Re: TransPort Colorado – Sub-Area 2 – Master Plan (DA-1793-05) Submittal #2 – Response to Submission Review #1

We have reviewed Staff's 1st round of comments for Transport Colorado Sub-Area 2 MP Amendment and have attached our responses to those comments.

Tab #8 – Land Use Map Matrix

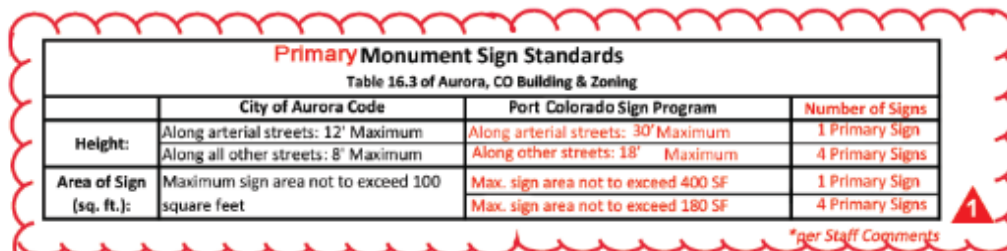
2D. Add the planned roads per the PIP on sheets 2 and 3.

RE: Numerous attempts were made to review this comment with COA staff without result. Like prior approved submittals the matrix has each development area with associated planning area map number. These “PAs” each have gross land areas in acreage which corresponds with the PIP. The planned roads are a part of each PA calculation.
